*Energy Harbor Nuclear Corp.
Beaver Valley Power Station
P.O. Box 4
Shippingport, PA 15077*

June 14, 2021
L-20-295

Beaver Valley Power Station, Unit Nos. 1 and 2
Docket No. 50-334, License No. DPR-66
Docket No. 50-412, License No. NPF-73
Emergency Plan Amendment Request

Subject: Request for licensing action to revise the Beaver Valley Power Station, Emergency Preparedness Plan to reduce on-shift staff positions, extend augmented Emergency Response Organization (ERO) response times, and re-align augmented ERO response positions.

EMERGENCY OPERATIONS FACILITY ORGANIZATION

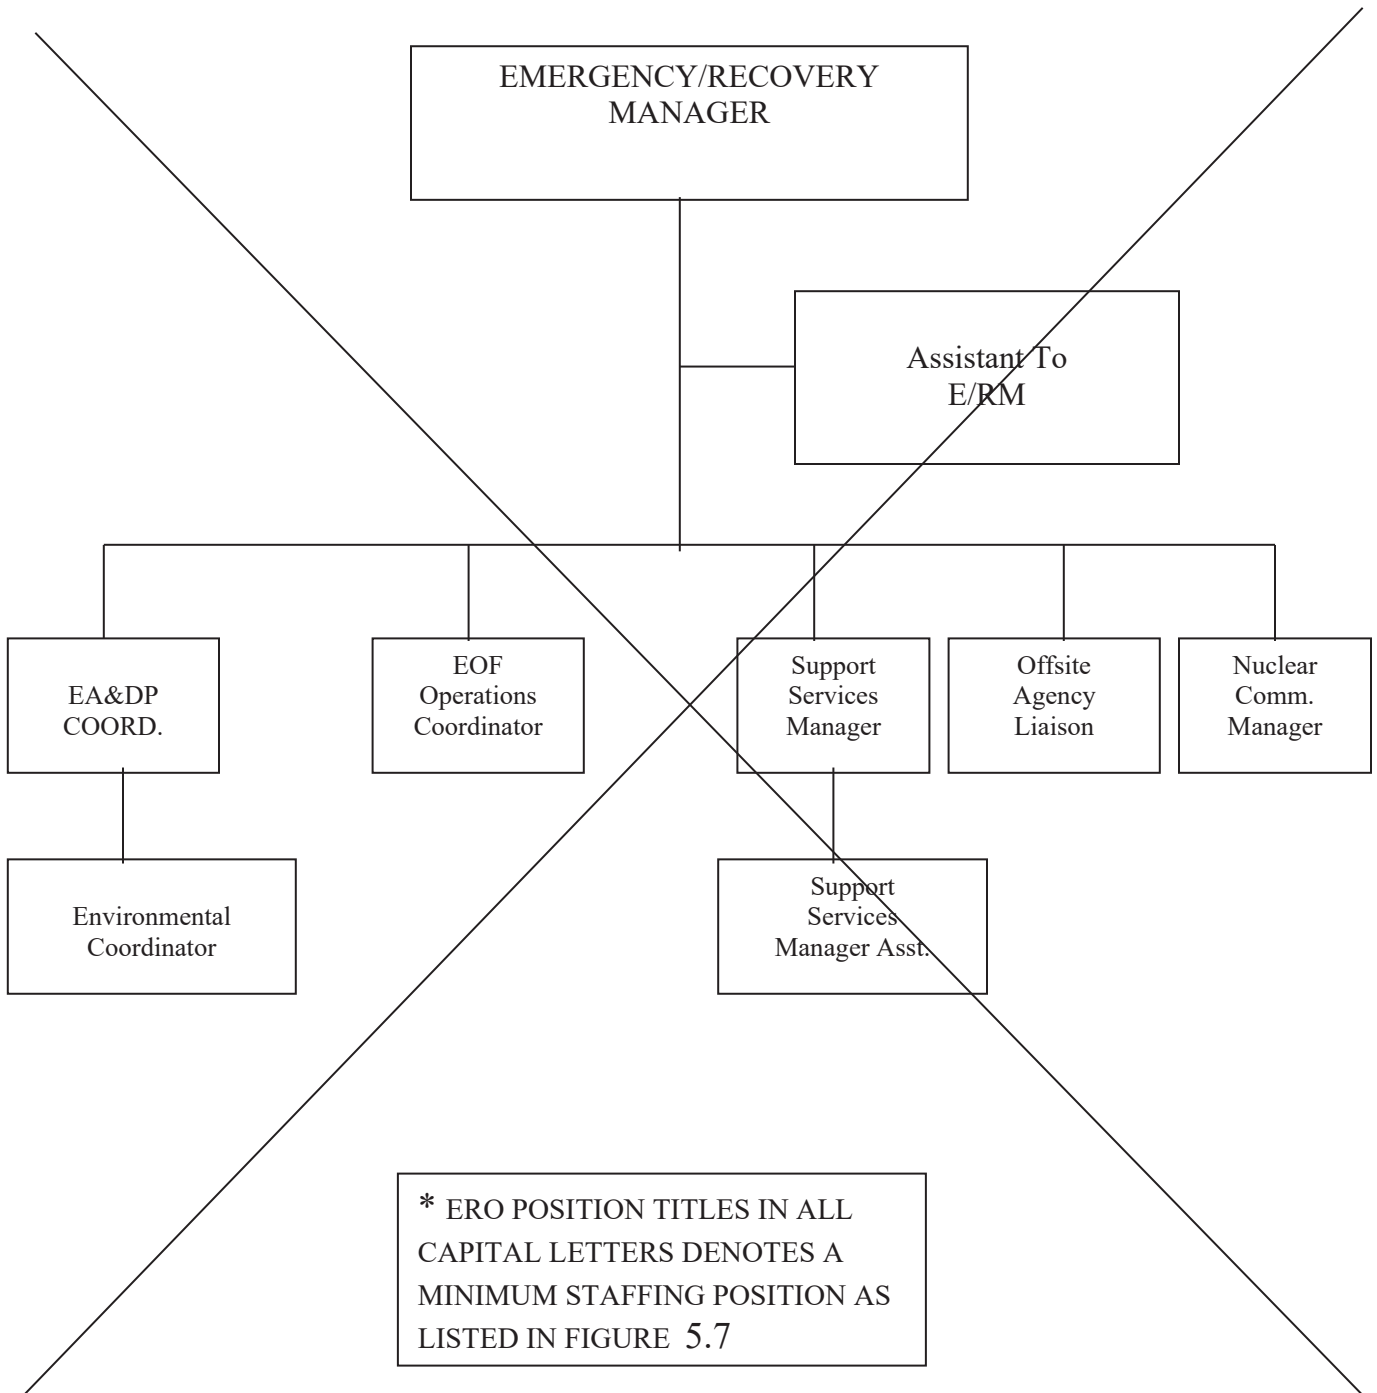
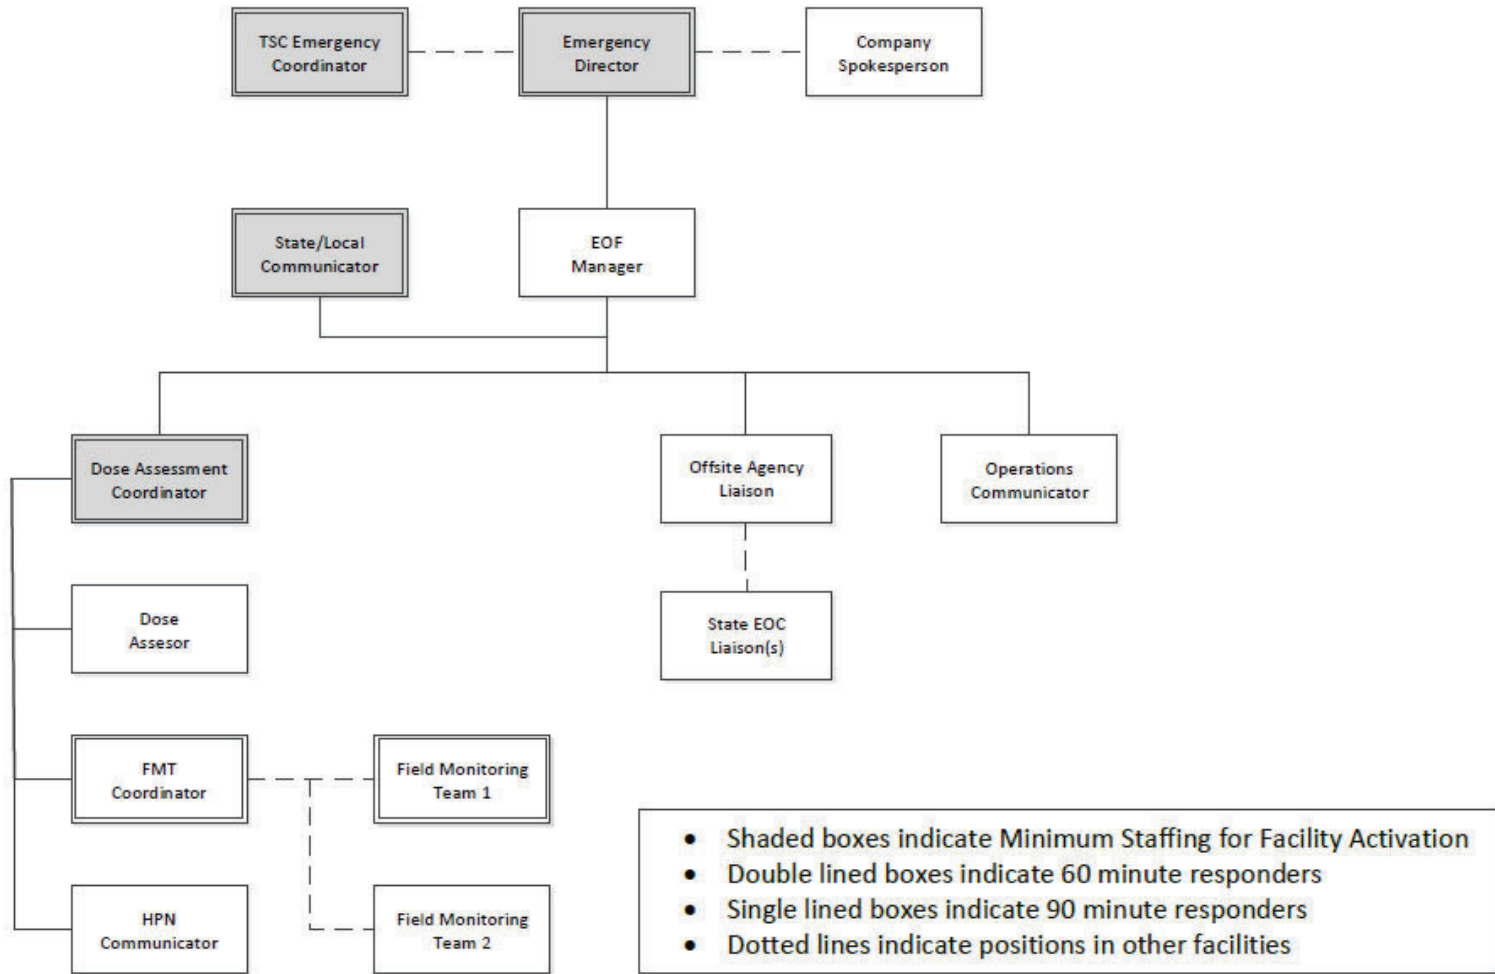
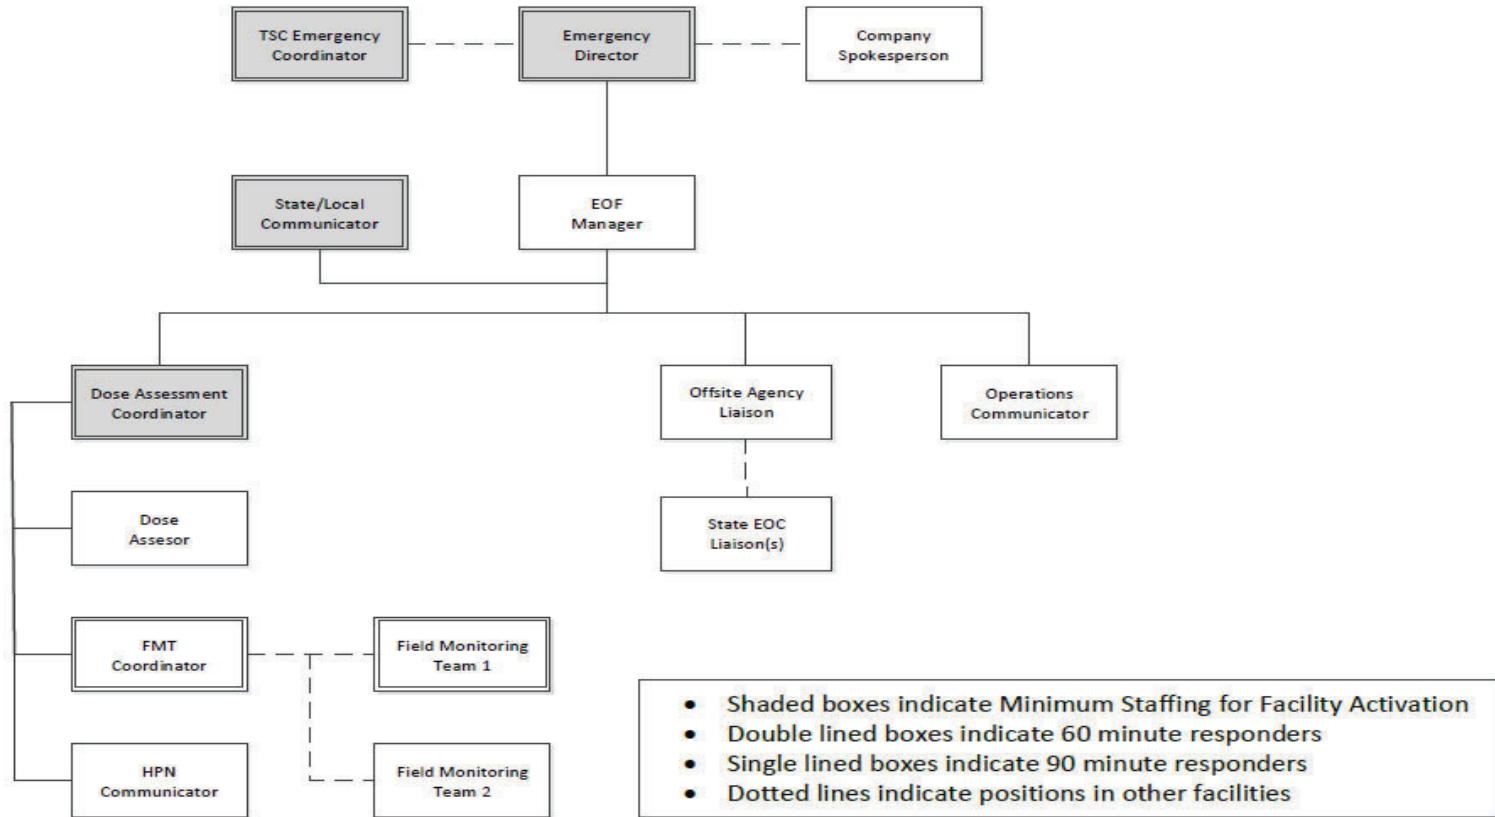
- qqq. Figure 5.5, Emergency Operations Facility Organization, revised to reflect changes in facility organization and minimum staff positions and renumbered from EPP Figure 5.4 to Figure 5.5 to reflect inclusion of OSC staffing as EPP Figure 5.4.

~~JOINT EMERGENCY PUBLIC INFORMATION RESPONSE ORGANIZATION~~ ^{c8}

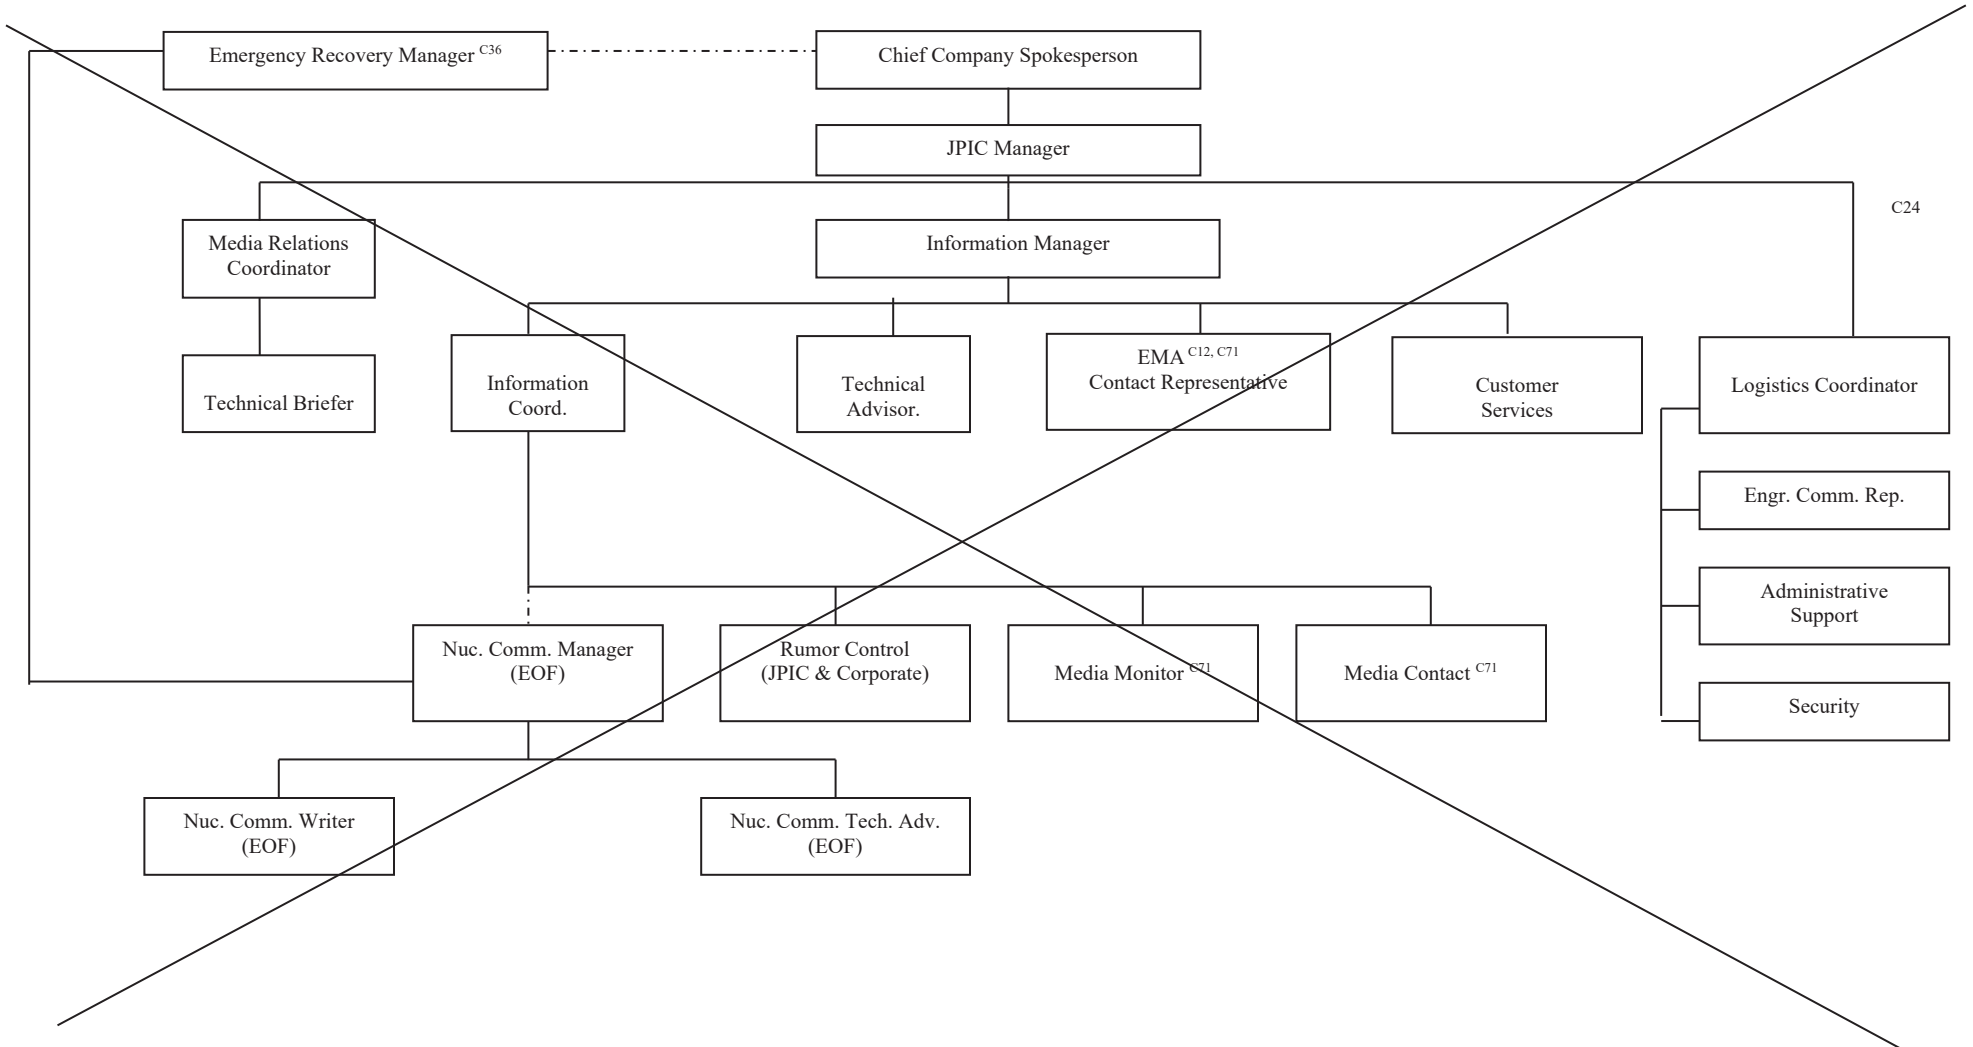
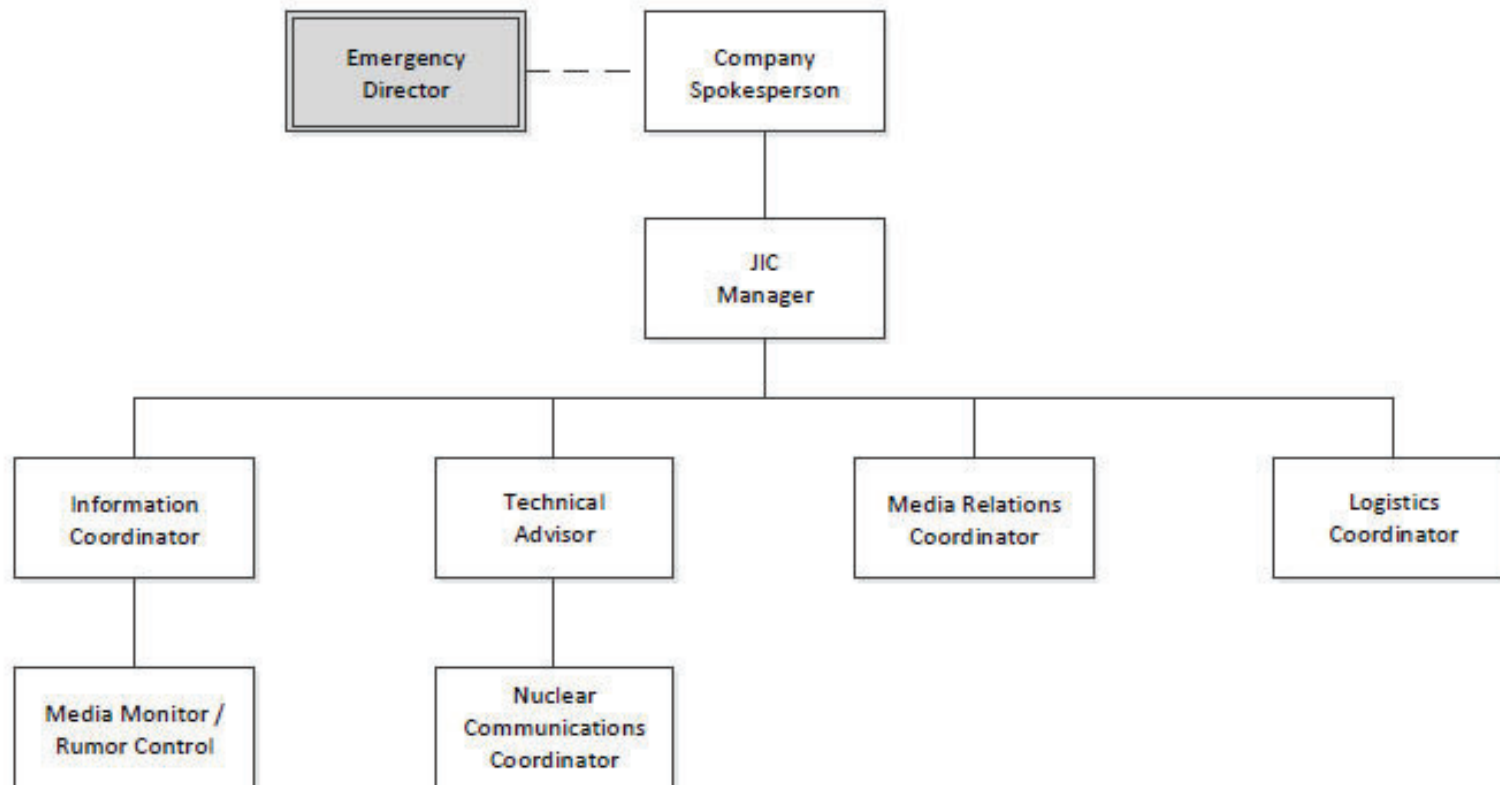
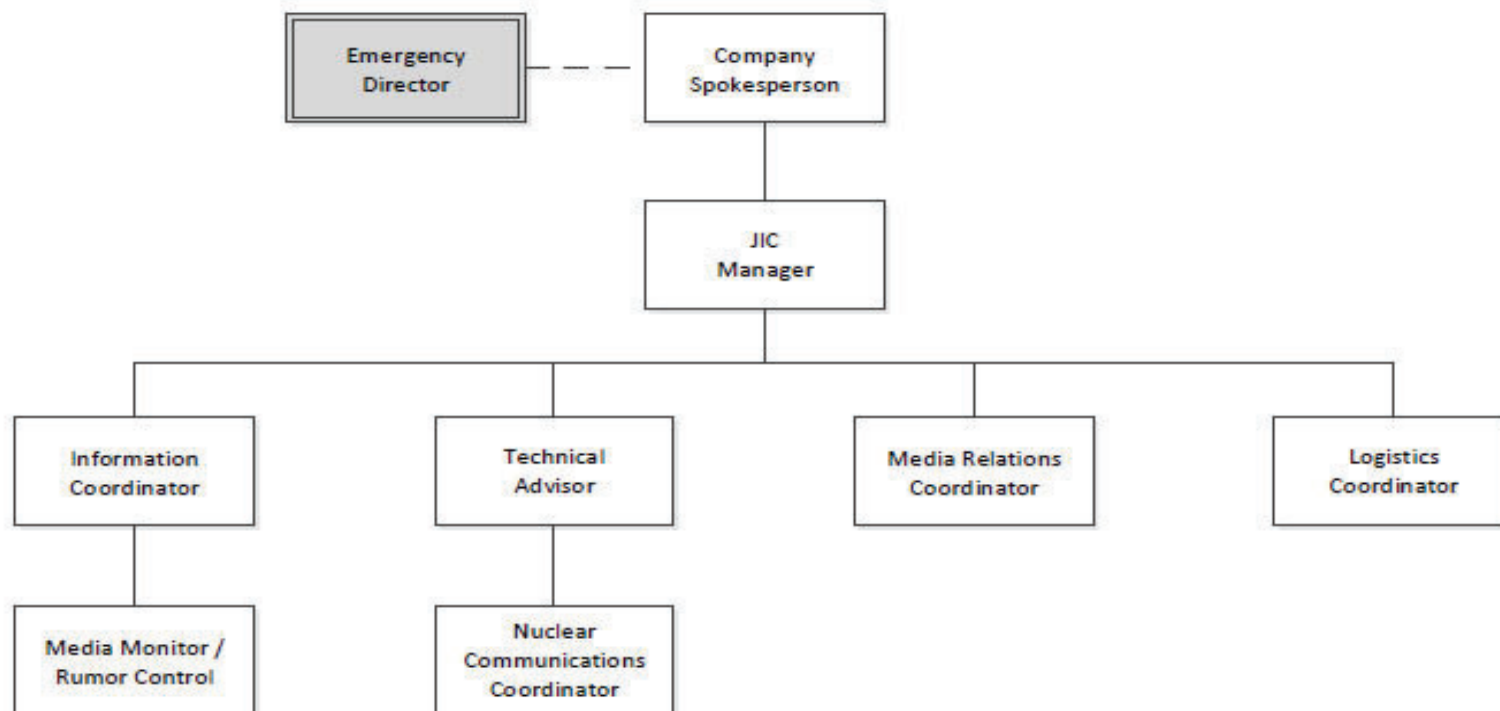
- rrr. Figure 5.6, Emergency Public Information Response Organization, renumbered from Figure 5.5 to Figure 5.6 to reflect inclusion of OSC staffing as EPP Figure 5.4 renamed to Joint Information Response Organization and revised to reflect changes in facility organization and staffing for the JIC.
